Subject: **Nationwide 12 & 33 Permit Application and Buffer Certification Modification** for the replacement of Bridge No. 30 over Green Mill Run on SR 1703 in Pitt County, Division 2. Federal Project No. BRSTP-1703(1), State Project No. 8.2221601, T.I.P. No. B-3685.

**SUBJECT: Response to the § 401 Water Quality Certification (DWQ Project No. 040995) requesting more information, TIP No. B-3685.**

**Re: Permit Application for proposed replacement of Bridge No. 30 over Green Mill Run on SR 1703 in Pitt County, Division2, TIP No. B-3685, DWQ No. 040995**

PROJECT REFERENCE NO. B-3685	SHEET NO. Sheet 5 of 9
ROADWAY DESIGN ENGINEER	HYDRAULICS ENGINEER
<b>PRELIMINARY PLANS</b> DO NOT USE FOR CONSTRUCTION <b>INCOMPLETE PLANS</b> DO NOT USE FOR R.F.W. ACQUISITION

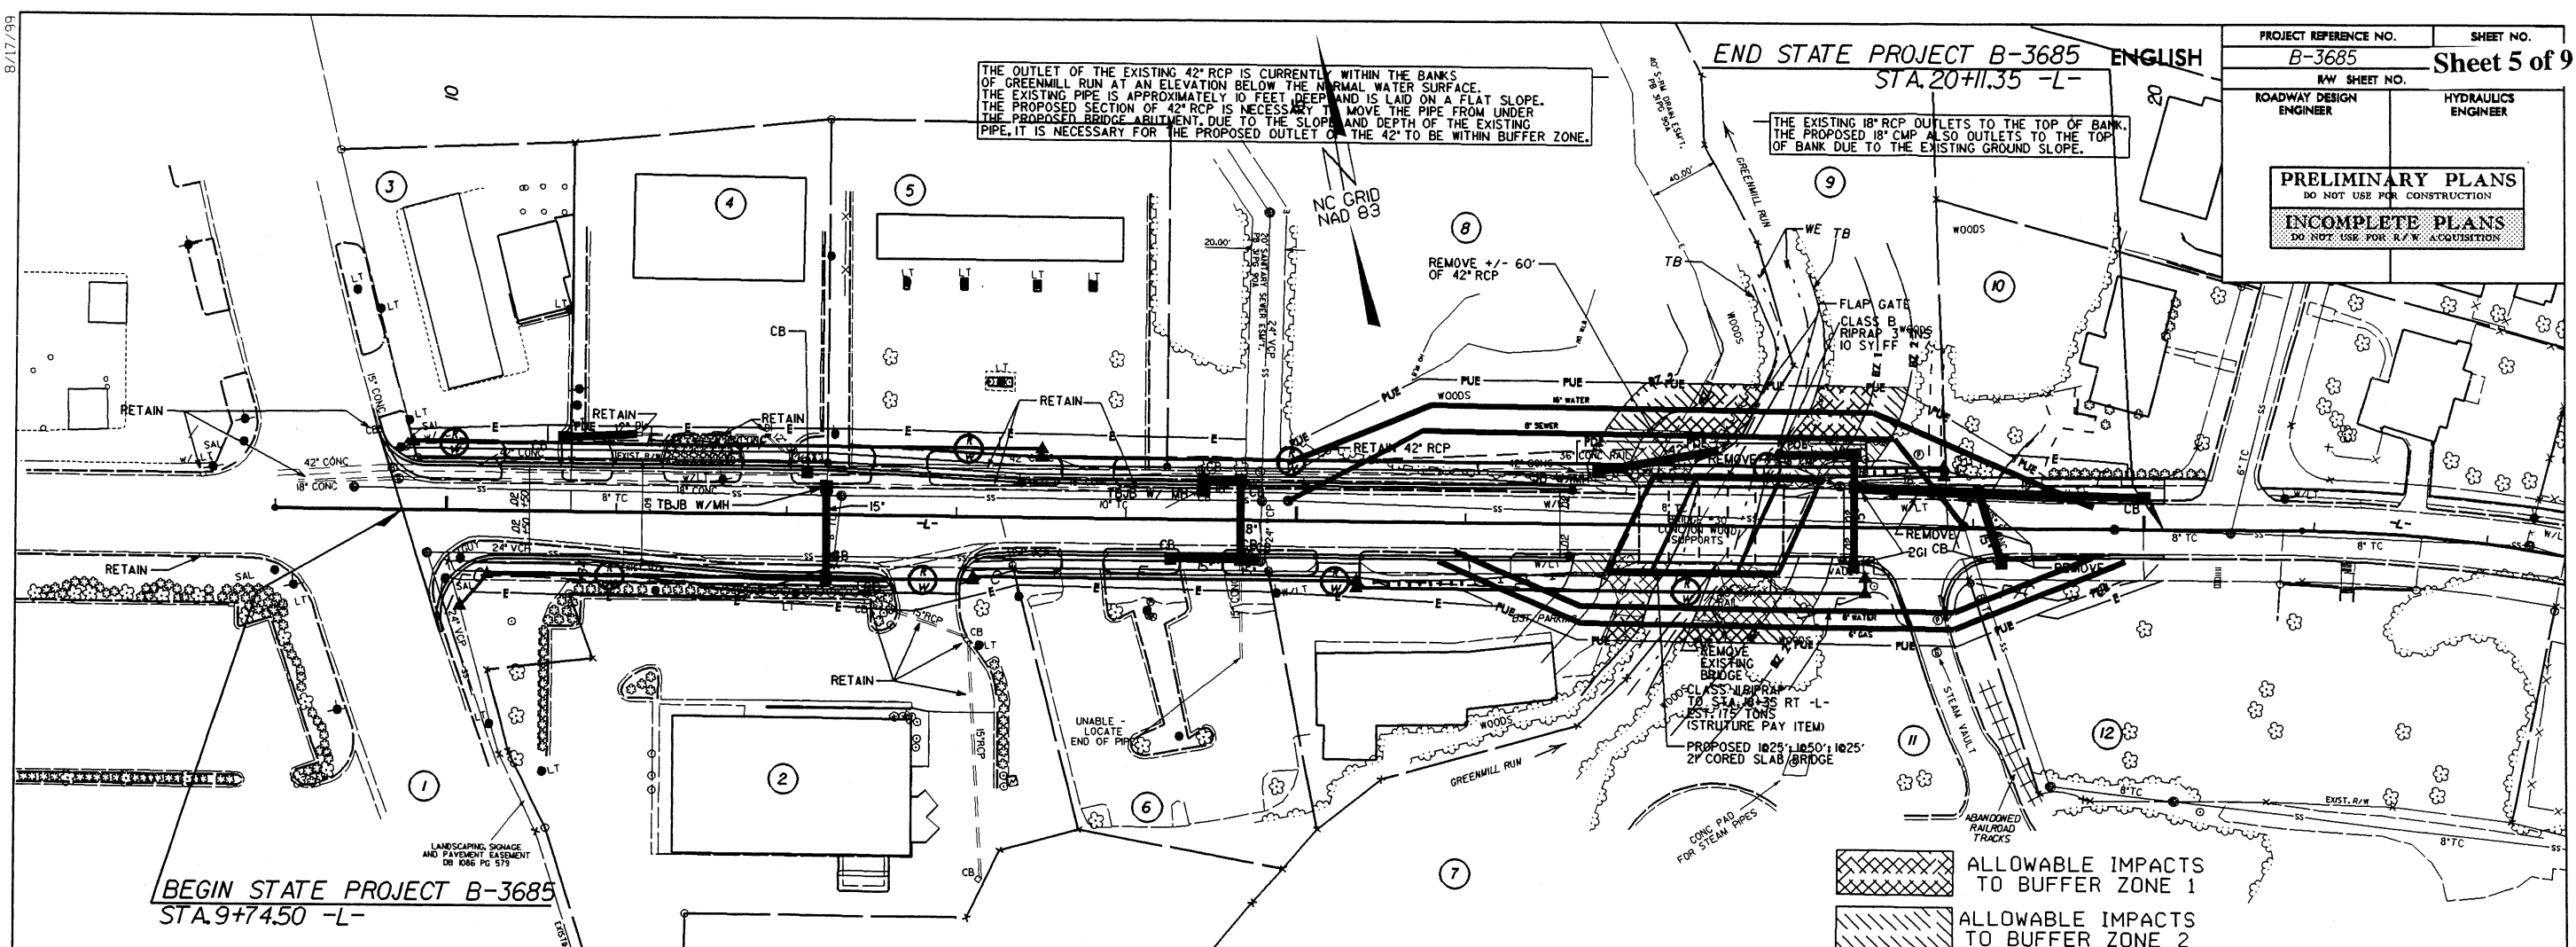
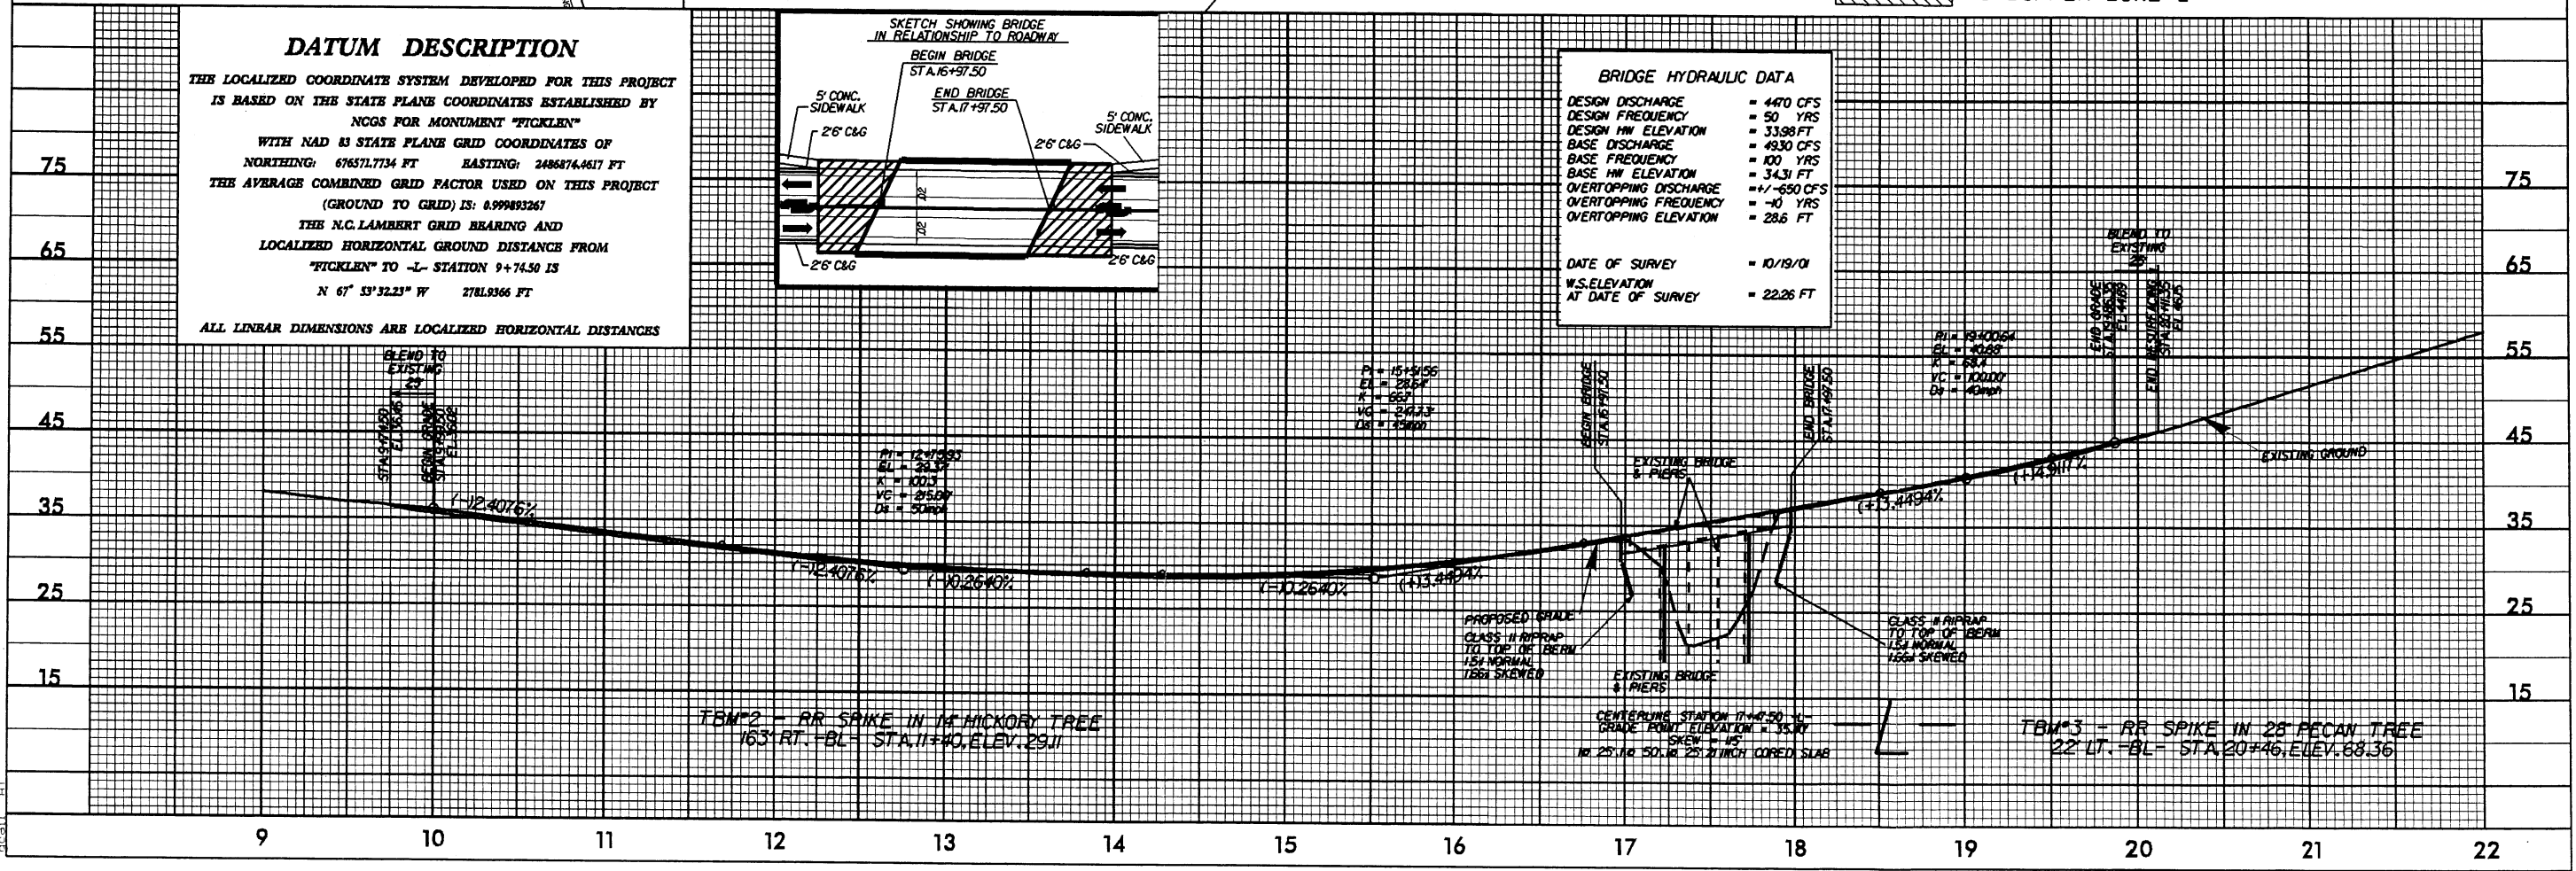
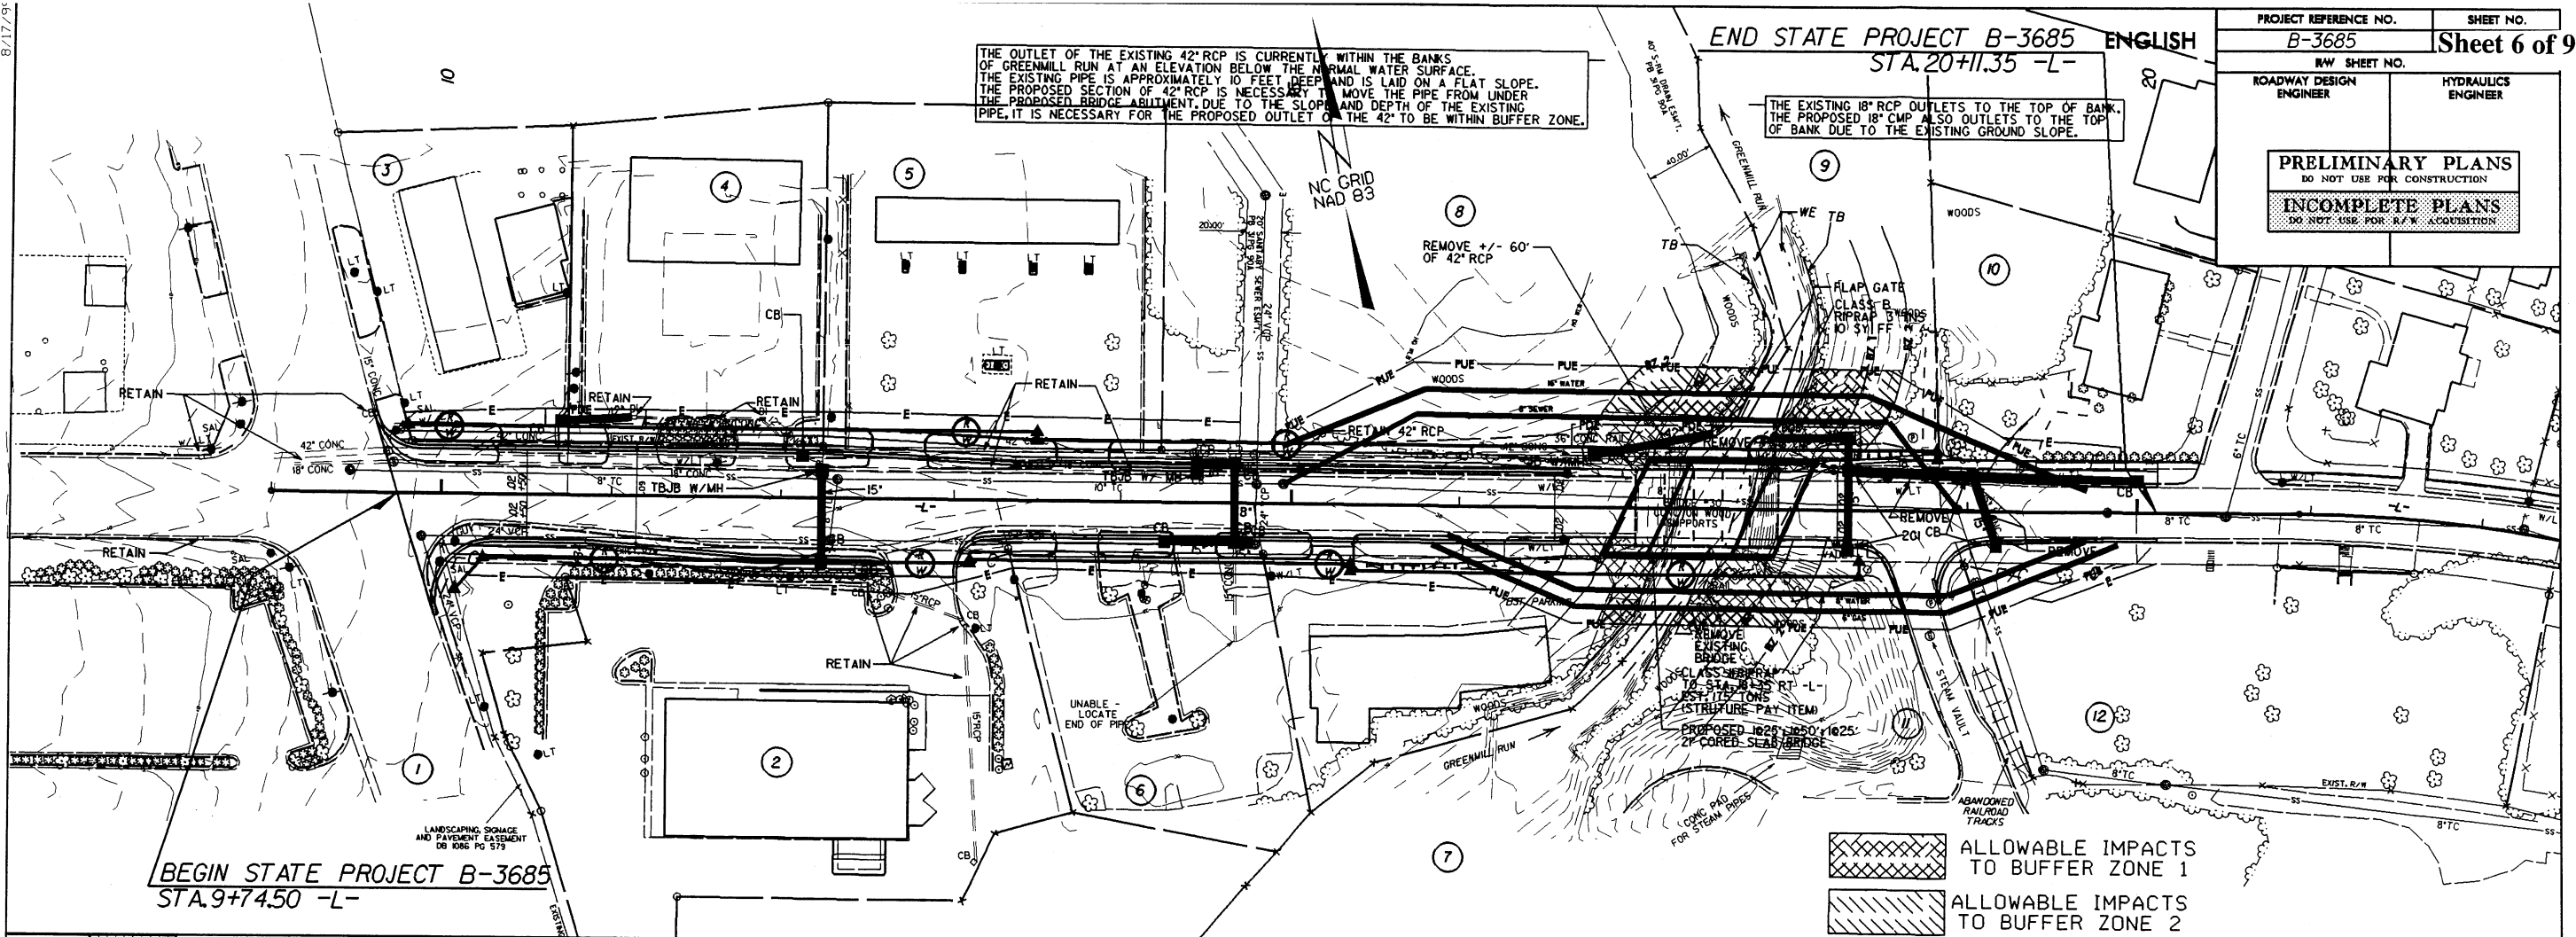
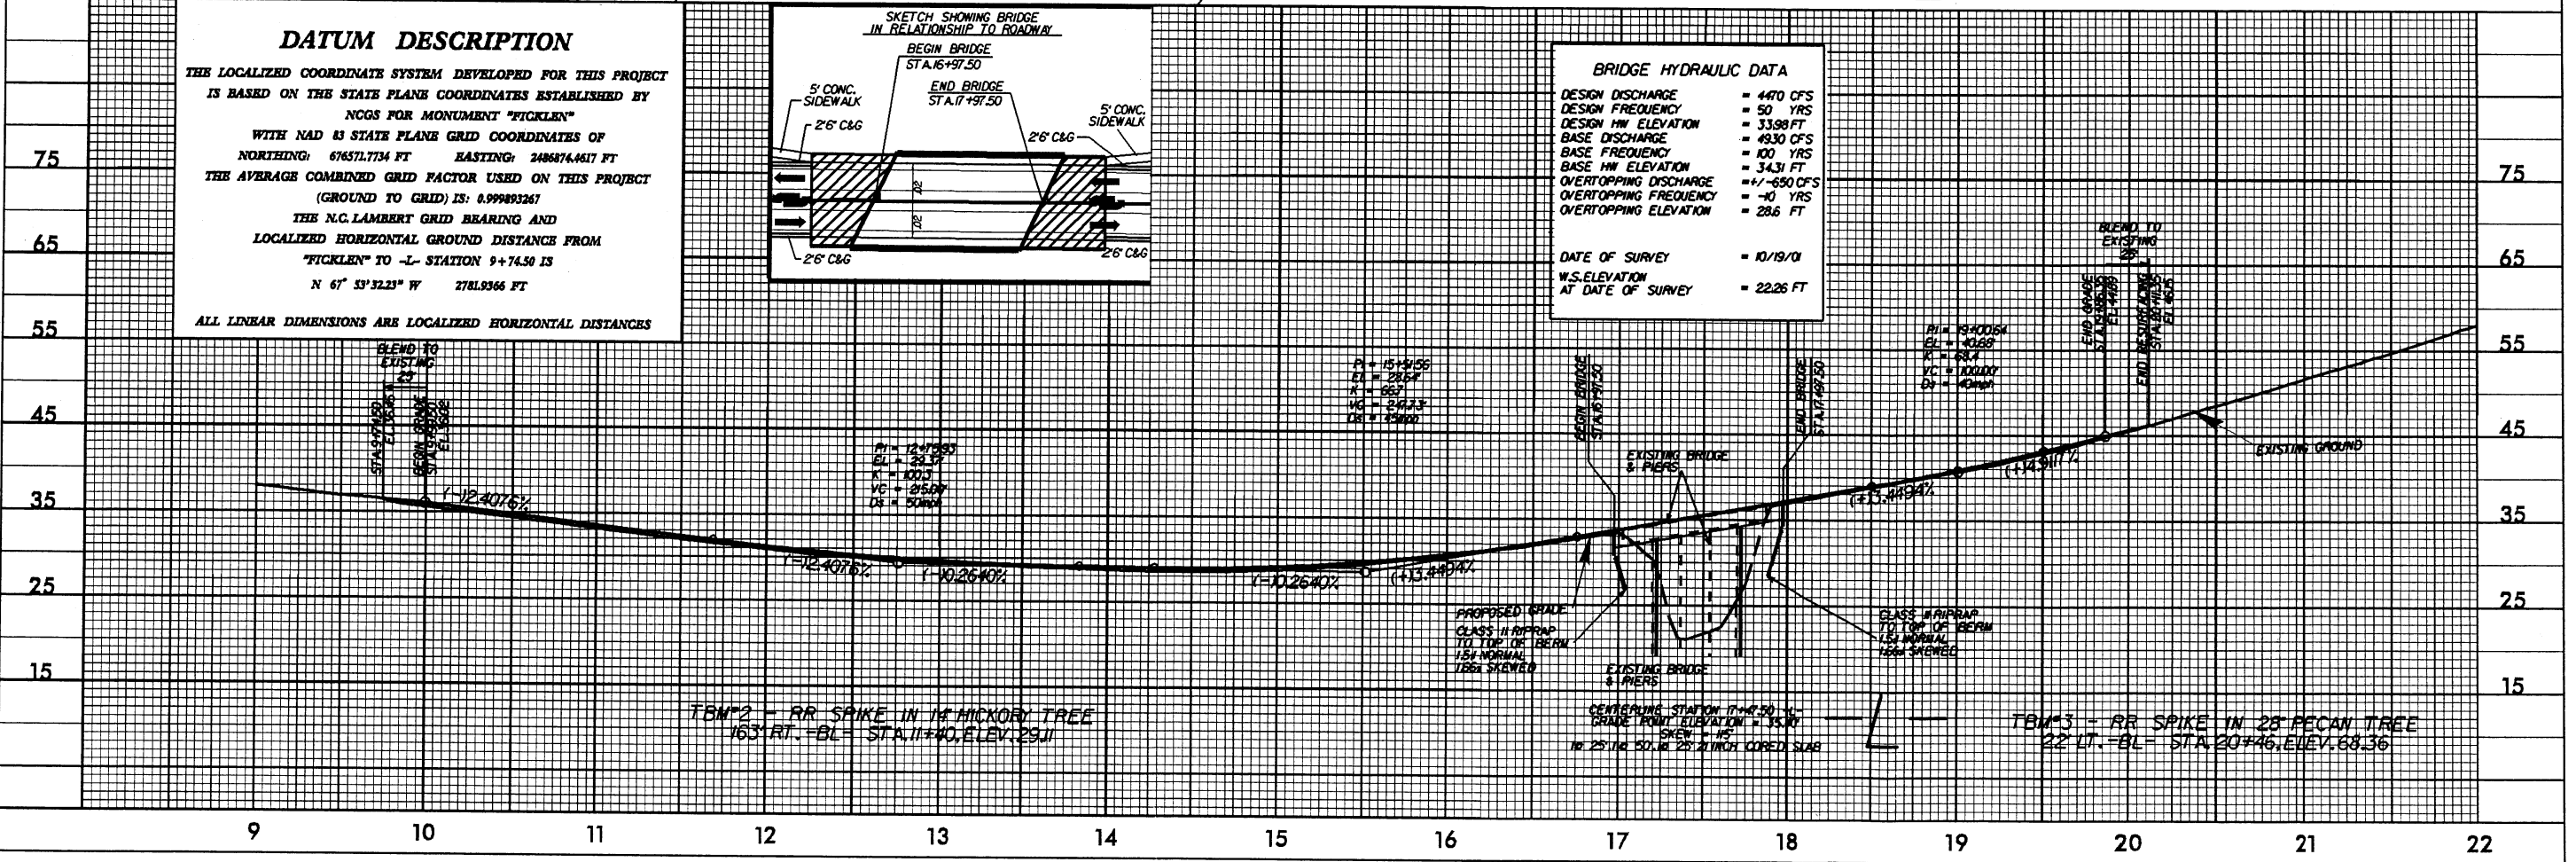
***NCDWQ Deficiency:** There is a proposed direct discharge into Green Mile Run without first providing diffuse flow a non-erosive velocities through the buffer. Please change your designs to rectify this issue.*

- There is a proposed direct discharge into Green Mile Run without first providing diffuse flow at nonerosive velocities through the buffer. Please change your designs to rectify this issue.

THE OUTLET OF THE EXISTING 42" RCP IS CURRENTLY WITHIN THE BANKS OF GREENMILL RUN AT AN ELEVATION BELOW THE NORMAL WATER SURFACE. THE EXISTING PIPE IS APPROXIMATELY 10 FEET DEEP AND IS LAID ON A FLAT SLOPE. THE PROPOSED SECTION OF 42" RCP IS NECESSARY TO MOVE THE PIPE FROM UNDER THE PROPOSED BRIDGE ABUTMENT. DUE TO THE SLOPE AND DEPTH OF THE EXISTING PIPE, IT IS NECESSARY FOR THE PROPOSED OUTLET OF THE 42" TO BE WITHIN BUFFER ZONE.

THE EXISTING 18" RCP OUTLETS TO THE TOP OF BANK. THE PROPOSED 18" CMP ALSO OUTLETS TO THE TOP OF BANK DUE TO THE EXISTING GROUND SLOPE.

**NCDOT Response:** There is direct discharge into Green Mill Run from West and East of the crossing. There is no means to get treatment for site drainage. The concern is how to diffuse flow. It was determined no practical alternatives could improve the existing site drainage based on the following:

West Side -An existing 42" trunkline just North of 14th Street conveys flow down to Green Mill Run. At the sag in the road approximately 250' West of the crossing the invert of the existing 42" is 23.0'. From here the 42" traverses to the stream to an elevation of 22.4' (slope = 0.24%). The natural ground elevation in the area of the sag is approximately 28.5' and at the outlet is approximately 26.0'. South of 14th Street is parking lot. Therefore, the only available area to diffuse flow is in the Northwest quad and this would require excavation (4') in the Green Mill Run floodplain. It is estimated the floodplain and roadway overtop in less than the 2 yr storm. So any excavation would be frequently inundated. Also, excavation would require the removal of trees, which are already scarce at this site. (the Northwest corner of the Green Mill Run crossing contains about the only significant stand of trees at the project site) Also, the additional stormwater generated from the project is negligible. Although there is widening, mainly on the West side of the crossing, there is additional grassed channelization.

East Side -An existing 18" trunkline just North of 14th Street conveys flow down to Green Mill Run. Due to the steep banks on this side of the crossing it was decided to outlet the 18" as the existing. There is a low area in the Southeast quad where an outlet was considered. However, water exiting a scour hole at this location would have to go down a steep embankment which would potentially create more erosion/sediment concerns than an outlet at the stream. Also, any scour hole would be frequently inundated.

Therefore, due to the frequent high water in Green Mill Run, the lack of area for attenuaters and the negligible increase in impervious area, it was determined the best (least erosive and maintenance intensive) means to outlet site drainage would be to outlet the systems as existing. The outlets will be submerged even under nominal storm frequencies and therefore outlet velocities will be less significant.
